Victoria North HIF Infrastructure and Enabling Works

Red Bank and Plateau Avenue
Stage 1 Road Safety Audit

Document Reference: 10030/01/00/02032022/cvl

Problem Location Plan 1 of 1

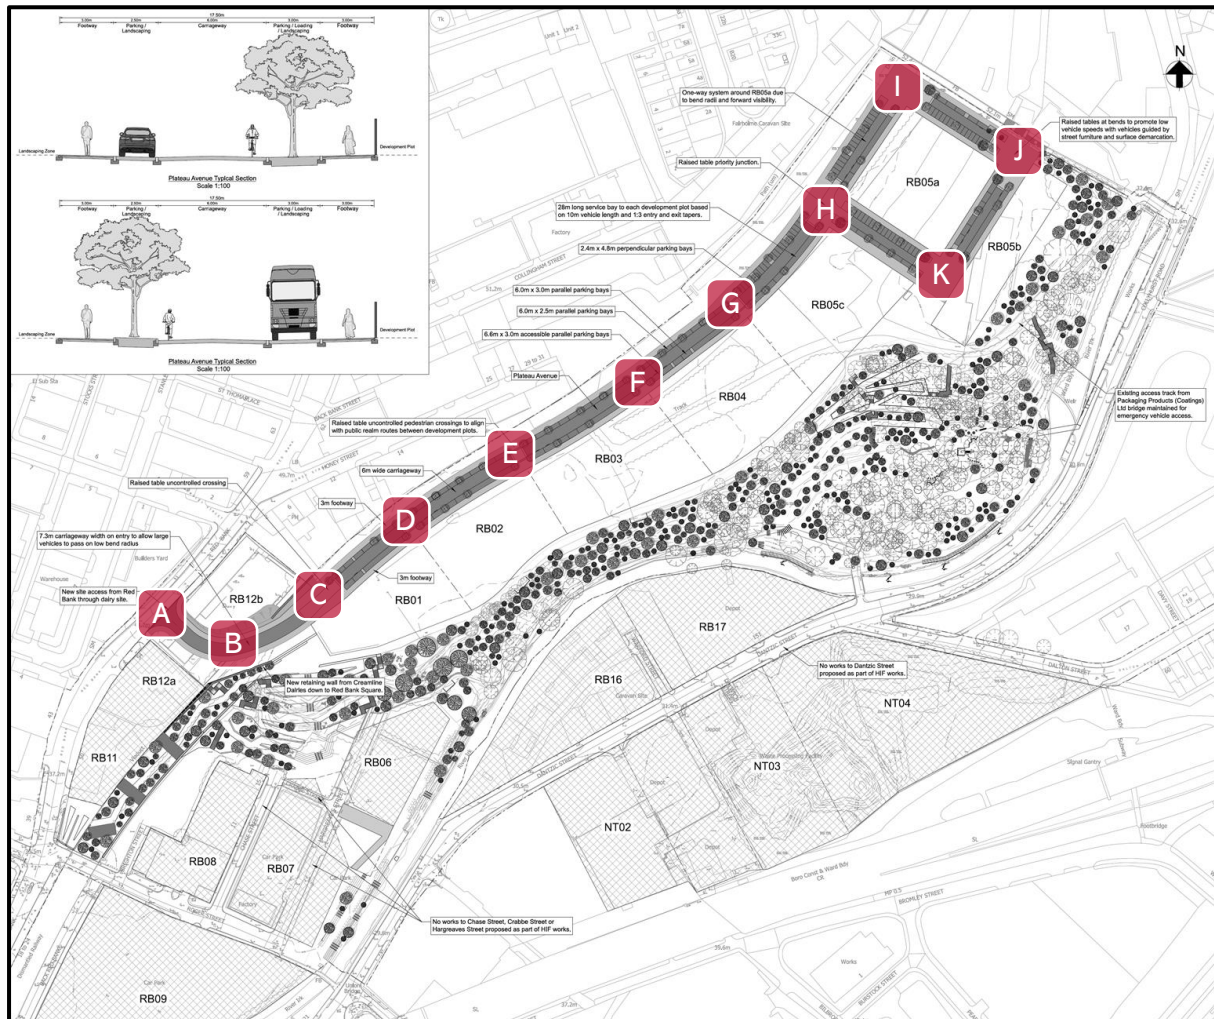
Location: A (See Figure 1)	Plateau Avenue, junction with Plateau Avenue
Drawing:	VNIF-ARP-00-YYY-DR-CH-0001
Summary:	High vehicle speeds leading to turning collisions
Problem:	High traffic speeds were observed on Red Bank, particularly vehicles travelling south-west (downhill). High traffic speeds through the junction could lead to misjudgements when turning into or across the traffic streams resulting in collisions between vehicles at the junction. Excess speed for a vehicle turning into the junction could lead to loss of control collisions.
Photograph:	 View northeast on Red Bank showing the approach gradient [P2241709.jpg]
Recommendation:	It is recommended that the designer introduce additional traffic calming to reduce traffic speeds on Red Bank.

Location: A (See Figure 1)	Plateau Avenue, junction with Plateau Avenue
Drawing:	VNIF-ARP-00-YYY-DR-CH-0001
Summary:	Missing informal crossing facilities leading to pedestrian injuries
Problem:	There are no pedestrian facilities proposed for the junction of Plateau Avenue with Red Bank. Full height kerbs can present a trip hazard for pedestrians, leading to trip and fall injuries. The mobility impaired use tactile paving surfaces to assist their navigation of the built environment and identify appropriate crossing locations. Missing tactile paving surfaces could result in injudicious crossing movements resulting in injuries to mobility impaired pedestrians."
Recommendation:	It is recommended that the designer provide dropped crossings with tactile paving surfaces to assist the movement of mobility impaired pedestrians at the junction.

Location: A through K	Plateau Avenue
Drawing:	282022/TN/001 & VNIF-ARP-00-YYY-DR-CH-0001
Summary:	Undefined development plot accesses leading to road user injuries
Problem:	The Site Access Junction Assessment refers to 159 additional parking spaced to be accommodated on development plots RB01 to RB05 and RB12b. The proposals do not provide any indication as to how vehicle access to these sites will be achieved. The provision of site accesses from Plateau Avenue could result in collisions with pedestrians and other road users on Plateau Avenue if appropriate visibility envelopes are not provided.
Recommendation:	It is recommended that the designer incorporate the individual development site accesses into the proposed layout for Plateau Avenue and the revised layout provided for road safety audit.

Location: B (See Figure 1)	Plateau Avenue
Drawing:	VNIF-ARP-00-YYY-DR-CH-0001 & VNIF-ARP-00-YYY-DR-CH-0002
Summary:	Narrow carriageway leading to sideswipe collisions
Problem:	The 7.3m wide carriageway of Plateau Avenue turns through a 30m radius bend on the approach to the junction with Red Bank. A standard carriageway width will not be able to safely accommodate HGVs on a low radius bend. This could lead to large vehicles overrunning the adjacent footway placing pedestrians at risk of collision injury.
Recommendation:	It is recommended that the designer undertake swept path analysis to determine any localised widening required and extend the centreline marking around the full extent of the bend to reduce the risk of collisions.

Location: C (See Figure 1)	Plateau Avenue
Drawing:	VNIF-ARP-00-YYY-DR-CH-0001
Summary:	Carriageway narrowing leading to pedestrian injuries
Problem:	The 7.3m wide carriageway of Plateau Avenue narrows to 6.0 over a raised table provided as an informal crossing point for pedestrians. This could lead to large vehicles overrunning the adjacent footway at the choke point placing pedestrians at risk of collision injury.
Recommendation:	It is recommended that the designer provide a consistent carriageway width over the full width of the raised table.

Location: C (See Figure 1)	Plateau Avenue
Drawing:	VNIF-ARP-00-YYY-DR-CH-0001
Summary:	Missing tactile paving surfaces leading to pedestrian injuries
Problem:	There are no tactile paving surfaces shown at the raised table uncontrolled crossing between plots RB01 and RB12b. The mobility impaired use tactile paving surfaces to assist their navigation of the built environment and identify appropriate crossing locations. Missing tactile paving surfaces could result in injudicious crossing movements resulting in injuries to mobility impaired pedestrians.
Recommendation:	It is recommended that the designer provide tactile paving surfaces to assist the movement of mobility impaired pedestrians over the raised table.

Location: C through K (See Figure 1)	Plateau Avenue
Drawing:	VNIF-ARP-00-YYY-DR-CH-0001
Summary:	Missing road markings leading to loss of control collisions
Problem:	The crossings, junction and low radius bends on Plateau Avenue are all located on raised tables. There are no shark tooth markings shown on the ramps to the raised tables. Sharks tooth markings are used to identify the ramps and encourage motorists to reduce their approach speed. In their absence, drivers and riders could fail to notice the tables, strike them at speed or brake suddenly and lose control.
Recommendation:	It is recommended that the designer provides appropriate markings on the faces of the ramps.

Location: D through G (See Figure 1)	Plateau Avenue
Drawing:	VNIF-ARP-00-YYY-DR-CH-0001
Summary:	Reduced crossing visibility leading to pedestrian injuries
Problem:	There are trees and parking bays located within the visibility envelopes for the raised table uncontrolled pedestrian crossings opposite plots RB01, RB02, PR03, RB04 and RB05a. Inadequate visibility for/of pedestrians at could lead to collisions between pedestrians and vehicles.
Recommendation:	It is recommended that the designer improve visibility for/of pedestrians at the crossings.

Location: H (See Figure 1)	Plateau Avenue
Drawing:	VNIF-ARP-00-YYY-DR-CH-0001
Summary:	Missing informal crossing facilities leading to pedestrian injuries
Problem:	There are no pedestrian facilities proposed for the junction between the two sections of Plateau Avenue. The mobility impaired use tactile paving surfaces to assist their navigation of the built environment and identify appropriate crossing locations. Missing tactile paving surfaces could result in injudicious crossing movements resulting in injuries to visually impaired pedestrians.
Recommendation:	It is recommended that the designer provide tactile paving surfaces and provide a contrasting carriageway surface to better define the pedestrian and vehicle environments to assist the movement of visually impaired pedestrians at the junction.

Location: I through K (See Figure 1)	Plot RB05a
Drawing:	VNIF-ARP-00-YYY-DR-CH-0001
Summary:	Poor carriageway definition at bends leading to pedestrian injuries
Problem:	There is no carriageway definition proposed for the three bends on the one-way section of Plateau Avenue. The mobility impaired use the kerb edge to assist their navigation of the built environment and remain within pedestrian areas. The lack of kerb edge could result in injudicious pedestrian movements resulting in collision injuries to visually impaired pedestrians.
Recommendation:	It is recommended that the designer provide physical delineation of the carriageway around the bends and provide a contrasting carriageway surface to better define the pedestrian and vehicle environments for the visually impaired.

Location: H to I, I to J & K to H (See Figure 1)	Plot RB05a
Drawing:	VNIF-ARP-00-YYY-DR-CH-0001
Summary:	Inadequate carriageway width leading to vehicle damage
Problem:	The one-way section Plateau Avenue has a carriageway width of 4.5m adjacent to a number of perpendicular parking bays. The 4.5m carriageway width is insufficient for most vehicles to turn into and out of a perpendicular parking bay without encroaching on adjacent bays or the opposing verge. This is likely to result in damage to vehicles or street furniture.
Recommendation:	It is recommended that the designer increase the carriageway width to allow drivers to safely access the perpendicular parking bays.

Location: H through K (See Figure 1)	Plot RB05a
Drawing:	VNIF-ARP-00-YYY-DR-CH-0002
Summary:	Inadequate carriageway width leading to vehicle and street furniture damage
Problem:	The swept path analysis shows an HGV overrunning the kerb at the junction between the two sections of Plateau Avenue. This could lead to large vehicles overrunning the adjacent footway placing pedestrians at risk of collision injury.
Recommendation:	It is recommended that the designer provides appropriate carriageway width for expected vehicle types.
